# **MOUNT VICTORIA TO LITHGOW GREAT WESTERN HIGHWAY – FORTY BENDS UPGRADE**

Addendum Review of Environmental  
Factors – Whites Creek Crossing

OCTOBER 2014

**Figure 2-1: Concept layout of the revised proposal**

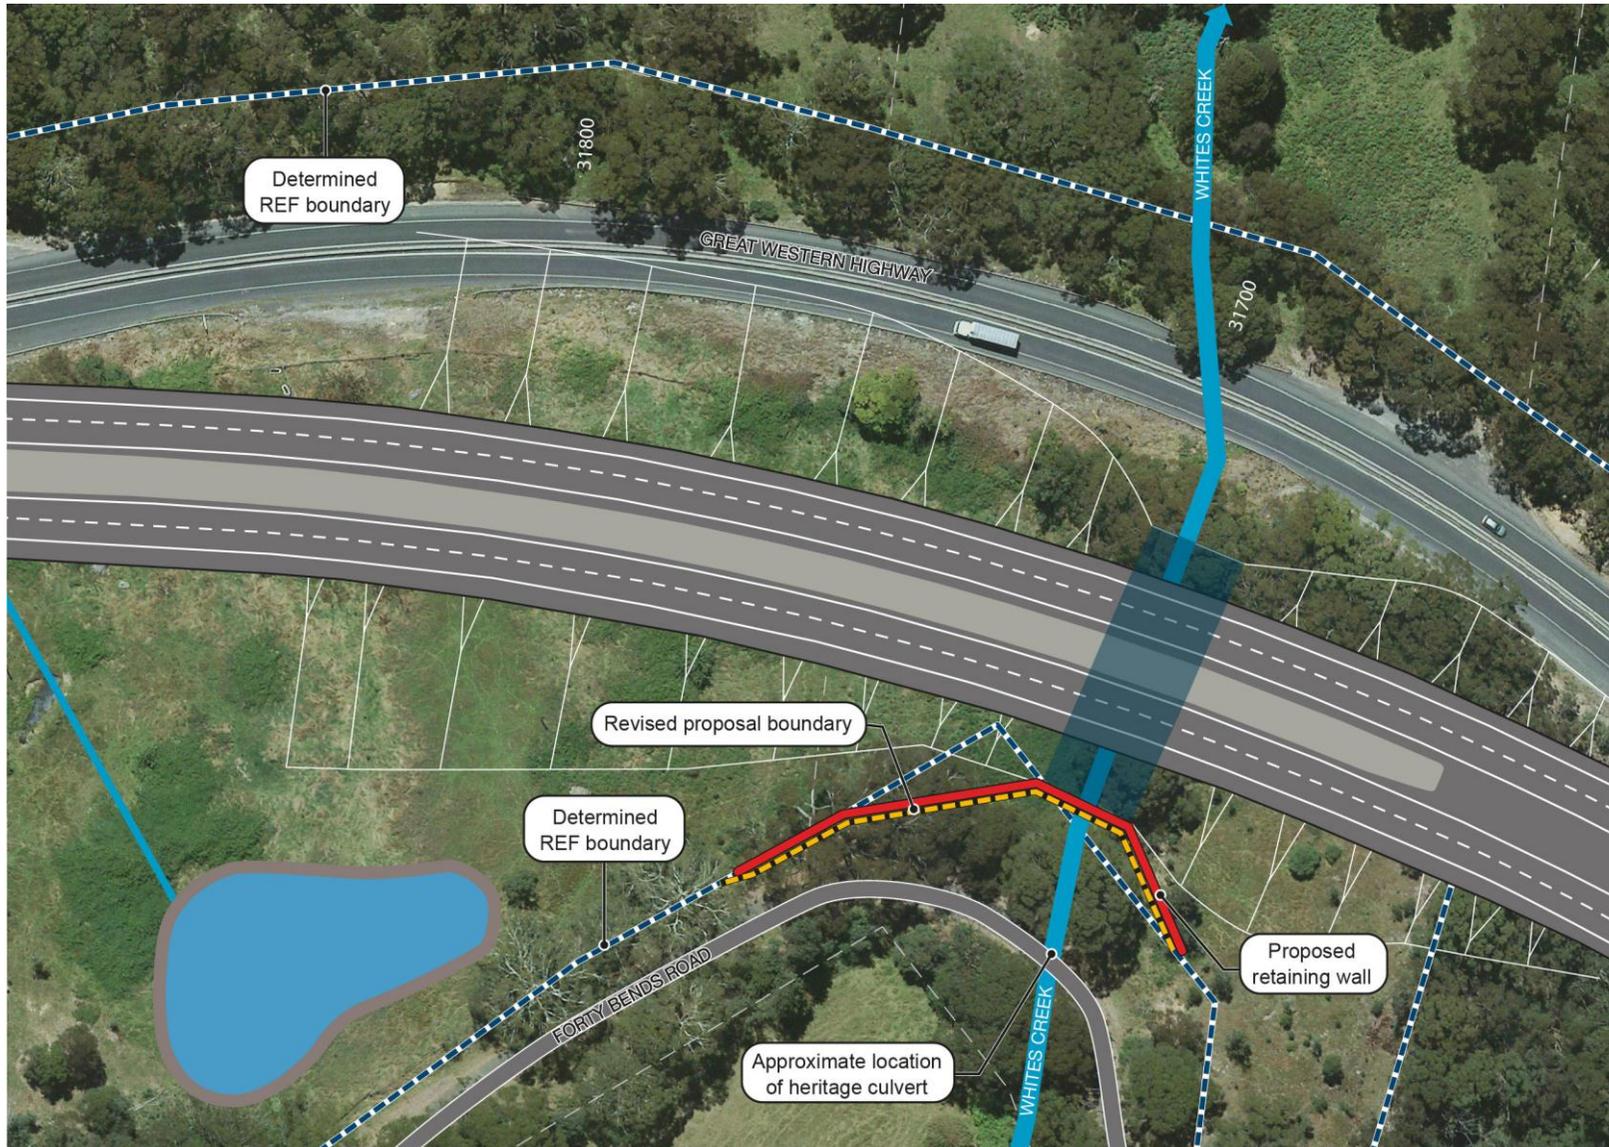
The revised proposal for the Whites Creek crossing would result in a similar area of impact to the determined proposal. A small change to the determined proposal boundary identified in the determined REF would be required to accommodate the revised proposal. The proposed change to the proposal boundary is shown in Figure 2-1.

The revised proposal to construct a pre-cast concrete arch structure and associated embankment would not require the acquisition or lease of additional private property. About 170 square metres of additional land currently vested in Lithgow Council would be required to the south of the revised proposal on the northern side of Forty Bends Road (refer to Figure 2-1).

Culvert 5 (refer to Figure 2-1) is part of a surviving section of the 1830's convict-built Mitchell's Road, and both the culvert and the road have at least local significance.

**Figure 2-2: Concept long section of the revised proposal**

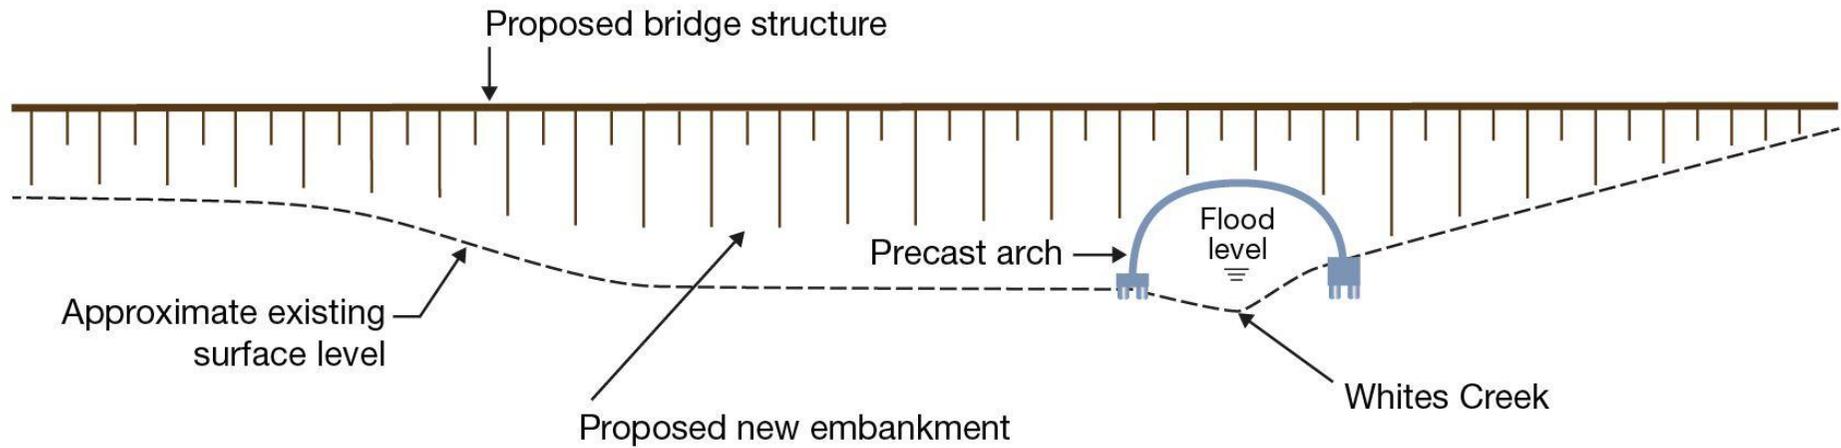
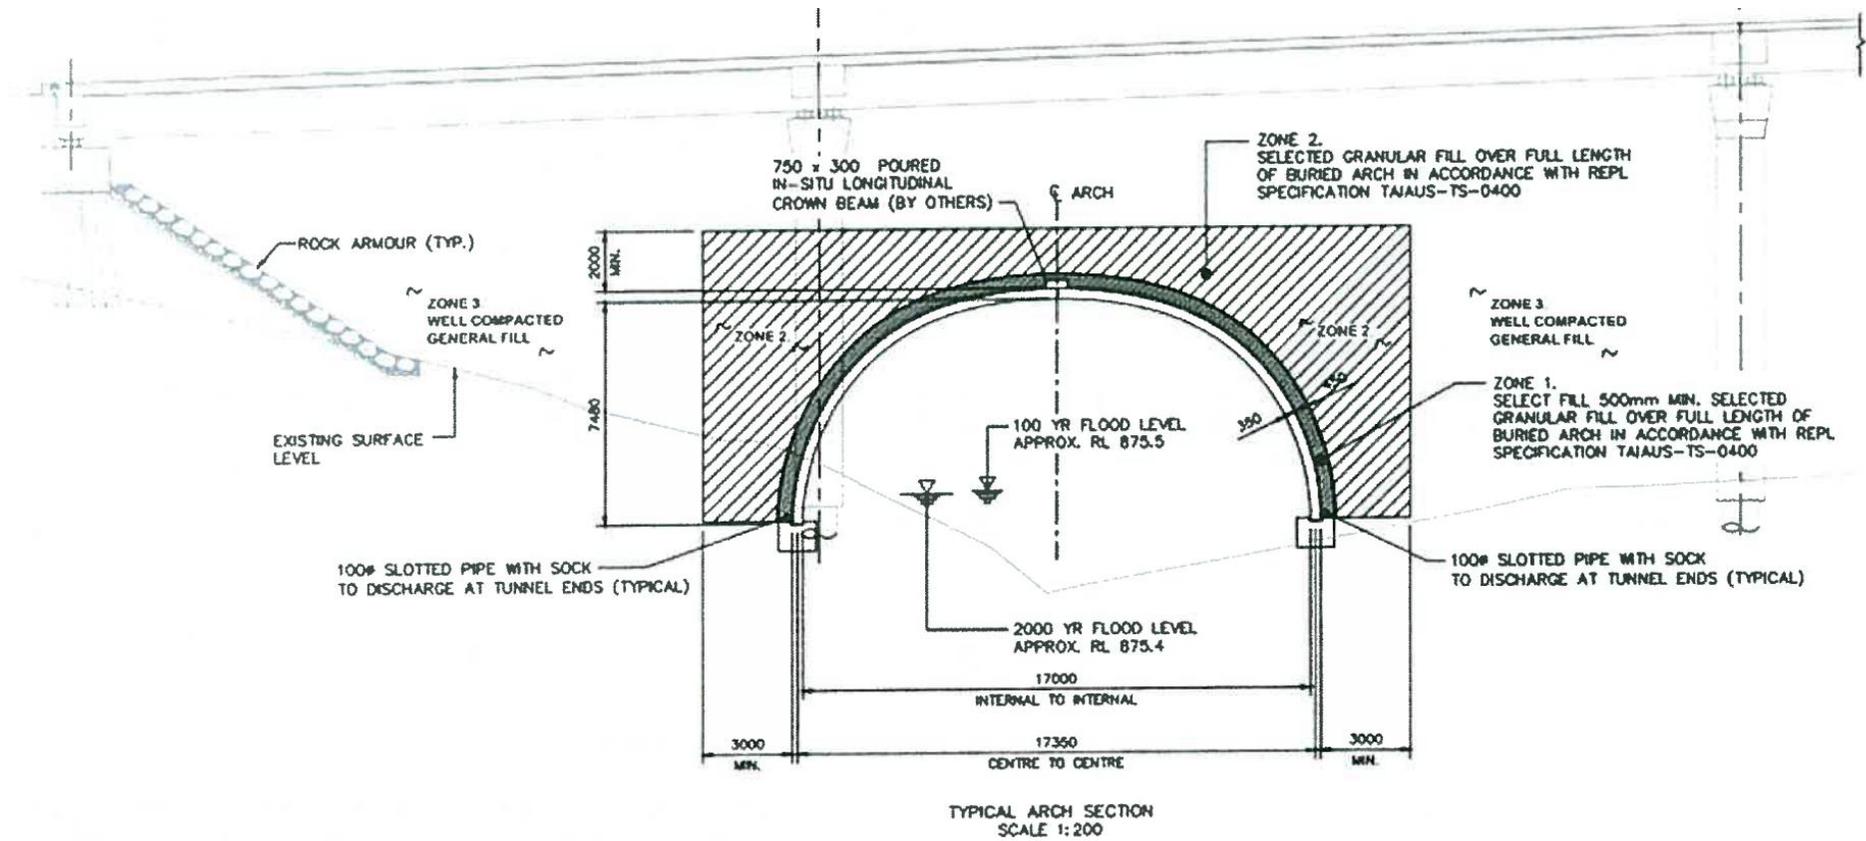
An overview of the revised proposal showing key features and revised construction proposal footprint is shown in Figure 2-1, Figure 2-2 and Figure 2-3.

Figure 2: Footprint of the revised proposal in relation to Culvert 5. The extent of the footprint of the revised proposal extends to the south into the road reserve of Forty Bends Road.

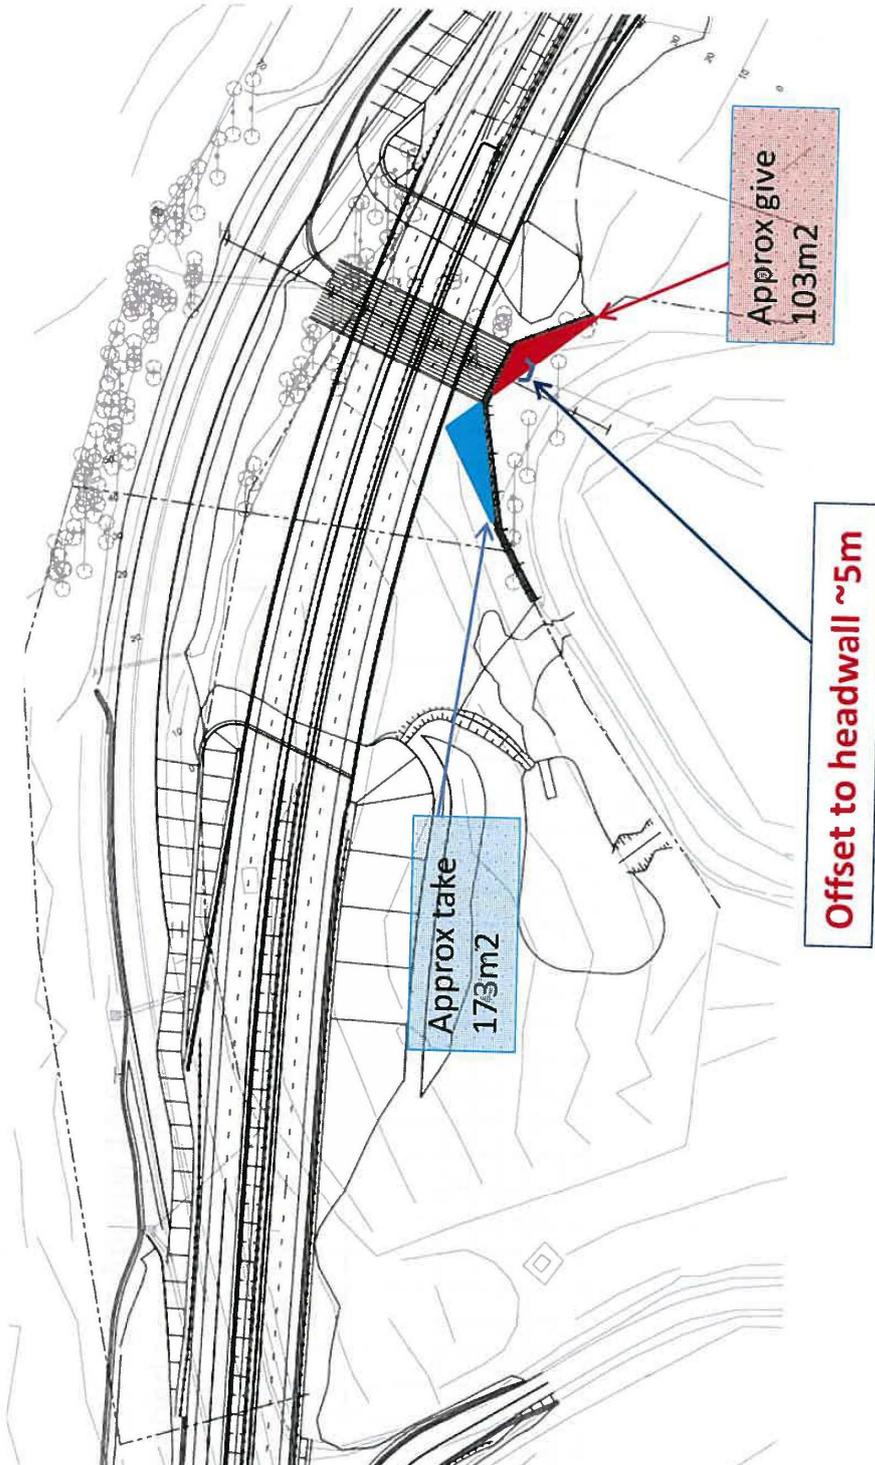
The proposal extends the footprint of the proposed works into the current road reserve for Forty Bends Road and closer to Culvert 5, Forty Bends Road (Figures 1, 2). Culvert 5 is located within the road reserve (Figure 5) and a 5m buffer has been established between it and the new arch. The height of arch at this point is 7.5m. The design option of the arch was investigated with a 10m buffer from Culvert 5; however the retaining walls would be about 18m high. This was considered to have a greater impact on the surrounding landscape character. Therefore a 5m buffer with a lower arch was considered to be more suitable for the landscape character of the country lane and still provide a gap between the culvert and the new design. Also offsetting the location of the arch in relation to Culvert 5 was considered but it would produce a high wall immediately behind the arch and change the hydrology in the area. This was not considered an acceptable solution.

The revised design provides for the retention of the surviving section of culvert but appears to have a high level of impact on the country lane appearance of the roadway in the area of Figure 13 and to the east (Figure 12). As shown in Figure 4 the embankment is very close to the existing line of Forty Bends Road at the western end and is a few metres from the western end of the road. The proposal is considered likely to have a major visual impact on the significance of this surviving section of Forty Bends Road. The impact on Culvert 5 is minor as the culvert is not intended to be visible in the landscape.

- Detailed design must ensure that there will be no impact on Culvert 5 or the road during or after construction.
- A curtilage of about 5 metres distance between Culvert 5 and the footprint of the new arch/embankment must be maintained so as not to provide physical and visual dominance over Culvert 5 and the 1830's line of road.
